SUBJECT: NATIONAL INSTITUTE OF STANDARDS AND TECHNOLOGY – REPORT ON  
THE REGULATORY AUDIT RE: RESTART REQUEST FOLLOWING  
EXCEEDANCE OF CLADDING TEMPERATURE SAFETY LIMIT  
(EPID: L-2021-LLN-0000)

REGULATORY AUDIT REPORT

NATIONAL BUREAU OF STANDARDS TEST REACTOR

Figure 3 - "Proper Latch Indication,"

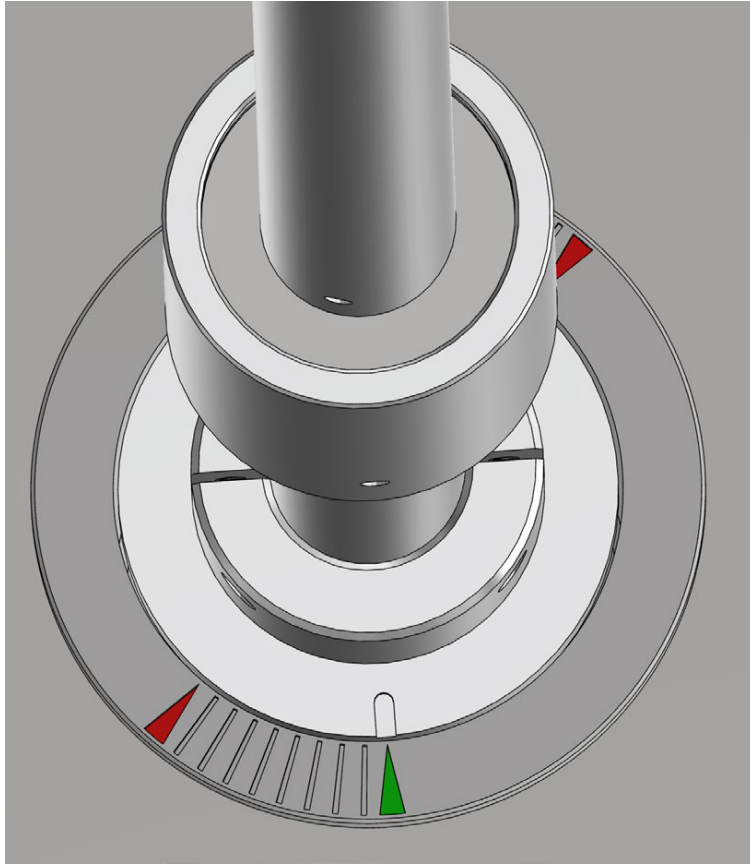
For the rotational latch verification, the NRC staff observed how the latch verification sleeves are inserted into the index plate holes and compared to the clutch tool's collar to ensure that the fuel elements are fully latched. Specifically, a check of the alignment of the clutch tool collar slot relative to the fully latched (Green) triangle marking on the sleeve (refer to the OI 6.1.7 figures below) was performed for each fuel element. For the visual check and the visual inspection analysis, the staff observed how the camera/video systems were assembled and used to perform the visual check of the position of each individual fuel element. After the video was completion for all 30 fuel elements, the NRC staff observed how the video was uploaded and reviewed to determine the position of each fuel element and to ensure it was fully latched. The EMIB staff considered that NIST is implementing a deliberate method to verify fuel element latching in the NBSR. NIST is conducting repetitive exercises for the fuel element latch process to train the reactor operators on the new process.

Figure 3, "Proper Latch Indication," in OI 6.1.7 (Revision 3) provides a visual depiction of a properly latched fuel element as shown below:

Figure 4 - "Improper Latch Indication"

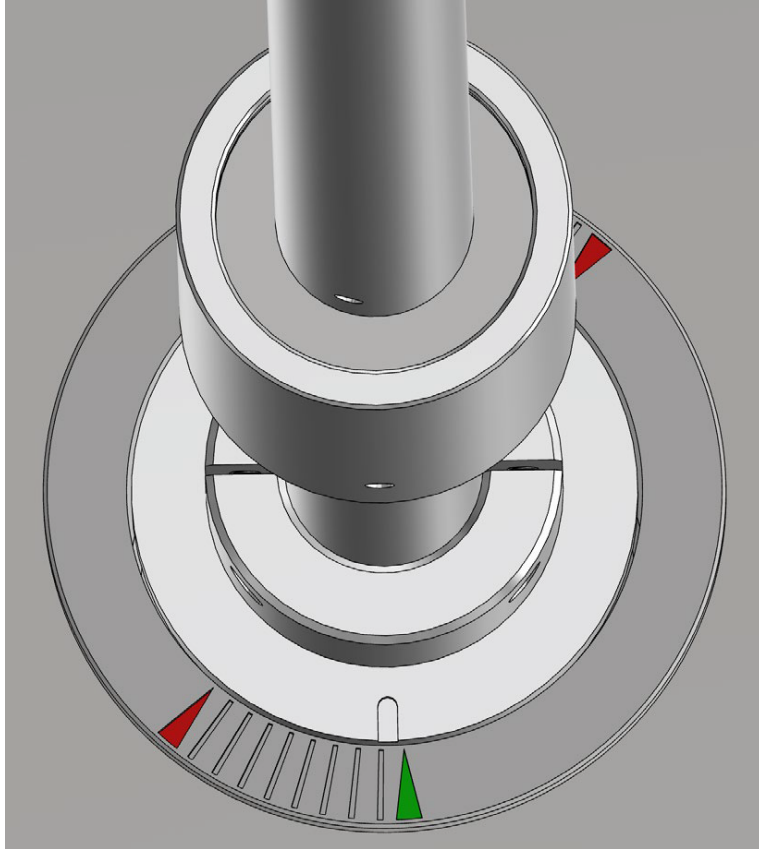
Figure 4, "Improper Latch Indication," in OI 6.1.7 (Revision 3) provides a visual depiction of an improperly latched fuel element as shown below:

Figure 13 - "Completed Sheet for Fuel Head Visual Inspection Analysis – Accepted,"

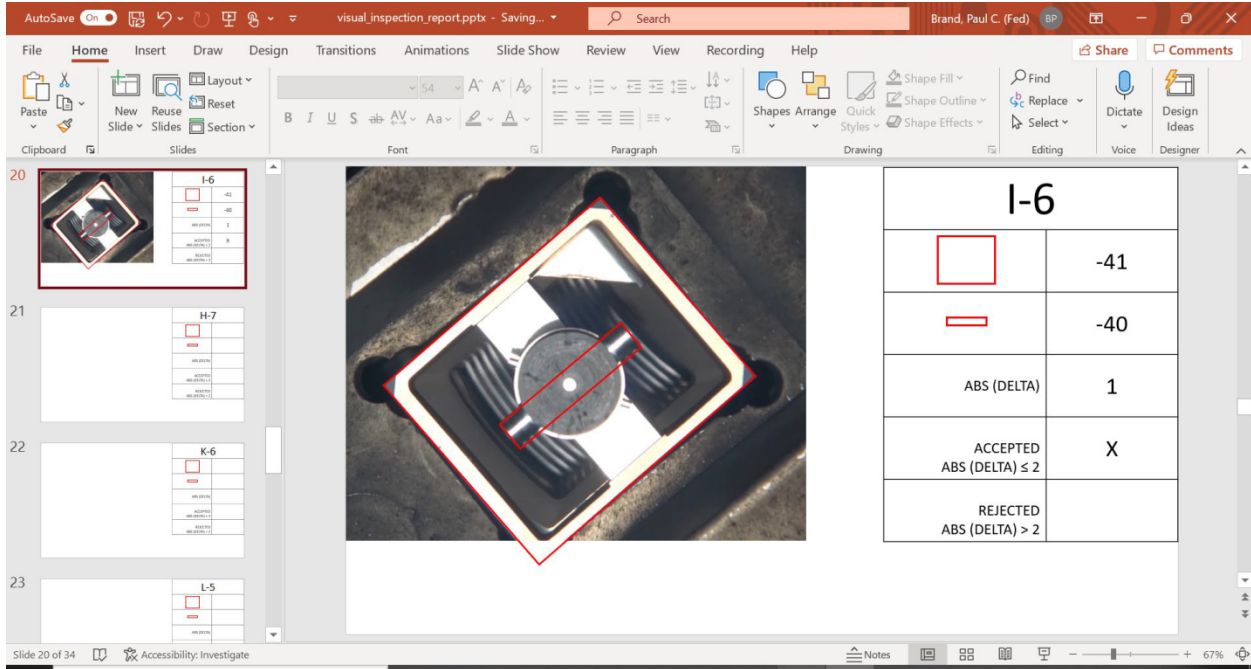
Figure 13, "Completed Sheet for Fuel Head Visual Inspection Analysis – Accepted," in OI 6.1.9 (Revision 3) shows the accepted position for the visual latch check verification as follows:

The photographs in these figures provide a clear demonstration that each fuel element is properly latched or is rejected as part of the visual latch check verification analysis.

Figure 14 - "Completed Sheet for Fuel Head Visual Inspection Analysis – Rejected,"

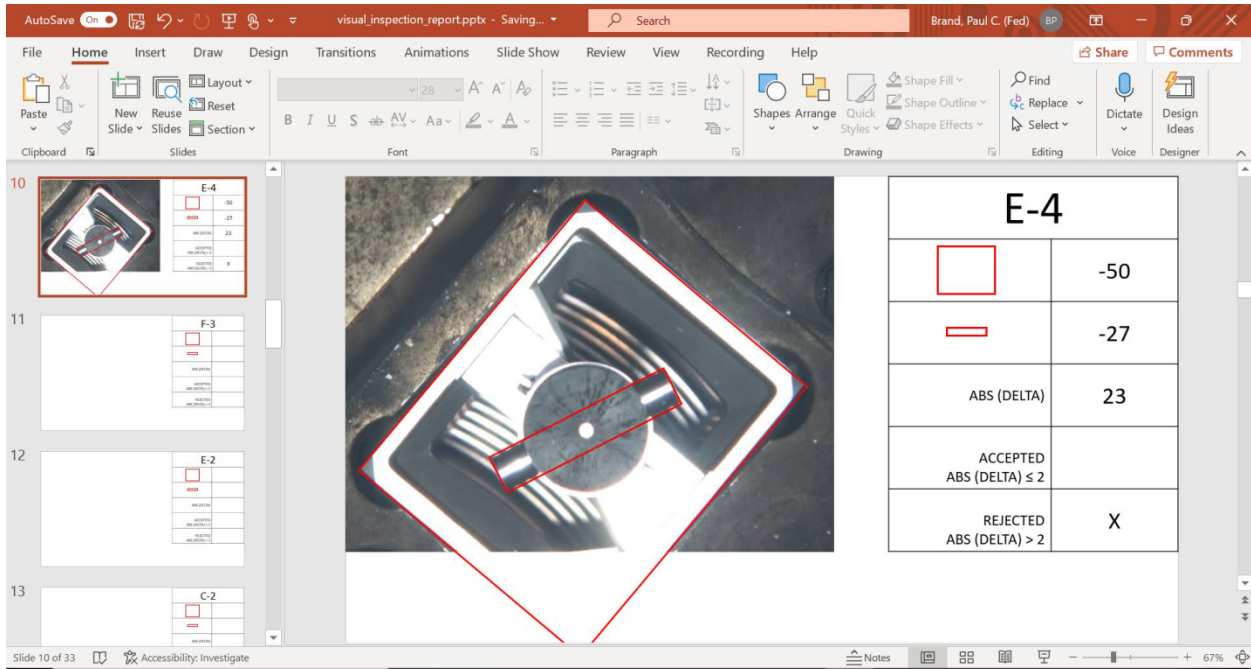
Figure 14, "Completed Sheet for Fuel Head Visual Inspection Analysis – Rejected," in OI 6.1.9 (Revision 3) shows an example of a rejected position during the visual latch check verification as follows:

**Figure 1. Fuel Flushing and Inspection Stand.**

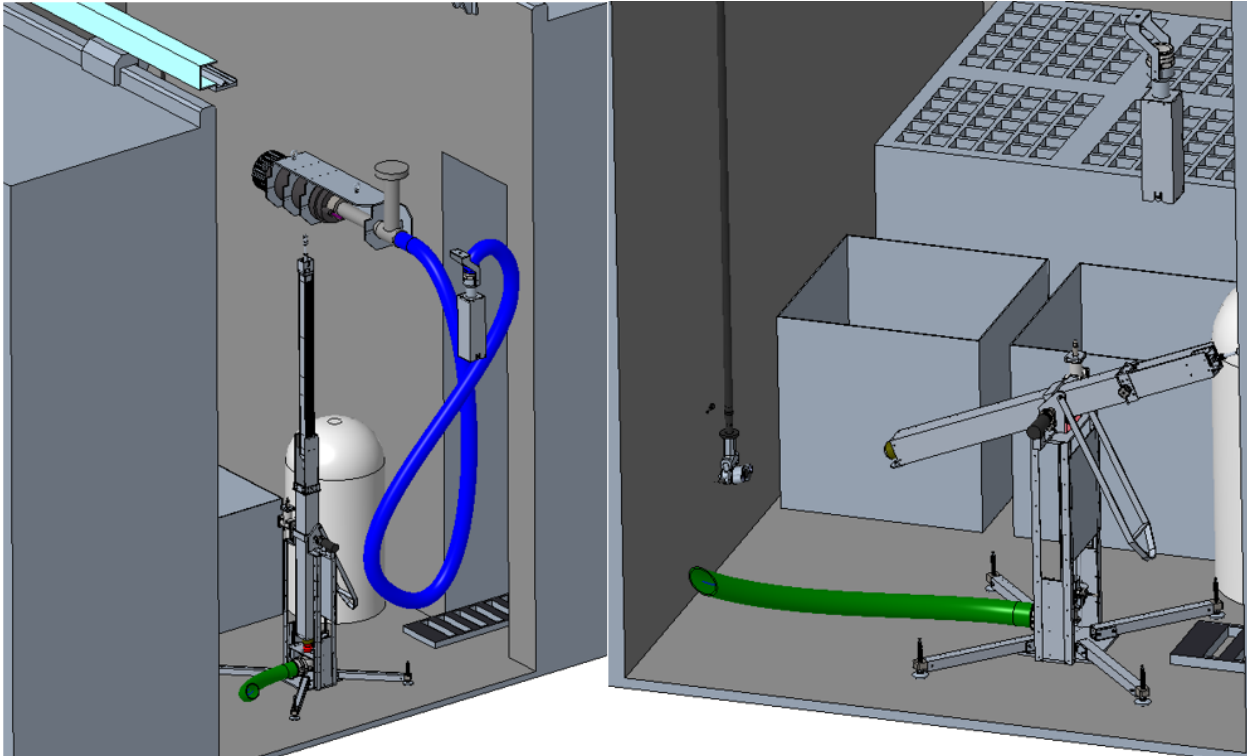
In the image above, the left side shows the assembly with a fuel bundle being loaded into the upright position. The blower is connected to the blue tube, and the green tube is the bundle outflow. On the right, a bundle is shown in the inspection position with a camera positioned (left side of right image) to inspect the lower portion of the bundle. The right image also shows the spent fuel rack (rear) and two bins where scraps are placed.

The NRC audit team observed the pre- and post-flushing inspections and actual flushing of Fuel Element 1151 onsite. In the upper fueled region, technicians identified deposits in the region between two fuel plates. In the lower fueled region, technicians identified debris in one location. The element was flushed with approximately 400 gallons per minute (gpm) flow, which exceeds the normal, upward flow of 267 gpm in each outer plenum element and 383 gpm in each inner plenum element. During the post-flushing inspection, technicians determined that the debris in the lower fueled region had been removed, leaving behind visible scratching on the fuel cladding on multiple plates. The material in the upper fueled region remained in place. Furthermore, technicians identified additional indications of material between other plates in the upper fueled region.

The NRC audit team clarified with NIST personnel how the above observations were being addressed. According to NIST, Fuel Element 1151 was returned upright for additional flushing. In accordance with procedure, if the initial flush does not remove foreign material, the bundle is flushed again for ten minutes. This additional flushing did not remove all material in Fuel Element 1151, and NIST was therefore unable to determine the bundle was suitable for reuse. In addition, NIST indicated that the scratching in the lower fuel region would also be evaluated, but that it was not in the fueled region. NIST will continue to evaluate the next steps for Fuel Element 1151, including potentially replacing it. Meanwhile, NIST continued to flush two additional fuel elements the same day. The first additional element was determined to be clean

**Figure 3. Superficial (i.e., not compromising cladding integrity) scratching observed on Element 1157.**

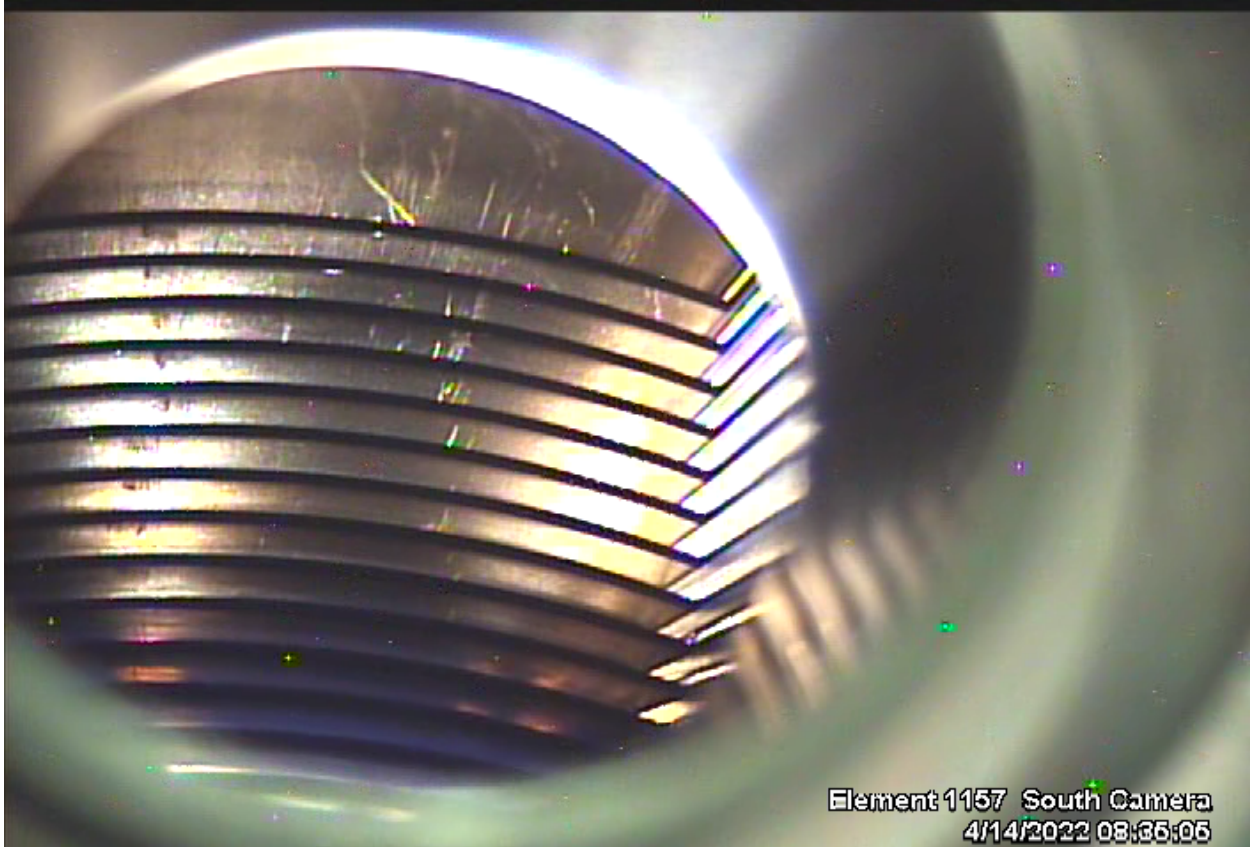
Following the completion of the flushing and inspection procedures, NIST personnel made available for NRC staff audit a preliminary disposition for the fuel. Four elements were identified as clean and, at the time, cleared for reuse. Three elements were identified as having probable fuel debris and were not cleared for reuse without further cleaning. The remaining 22 elements were determined to contain very small but visible debris. In comparison to a baseline inspection of other elements that were in the spent fuel pool but not present in the reactor, NIST personnel concluded that these 22 elements appeared somewhat similar to the condition of the other elements. Additionally, it was observed that 3 of the 22 elements with small debris had dented nozzles. Shown below is an image of Element 1155, which is believed to contain a nugget of fuel material. Also shown below is an image of Element 1157, in which superficial scratching can be seen on the element. NIST personnel indicated that, where observed, scratching did not appear to be indicative of cladding failure.
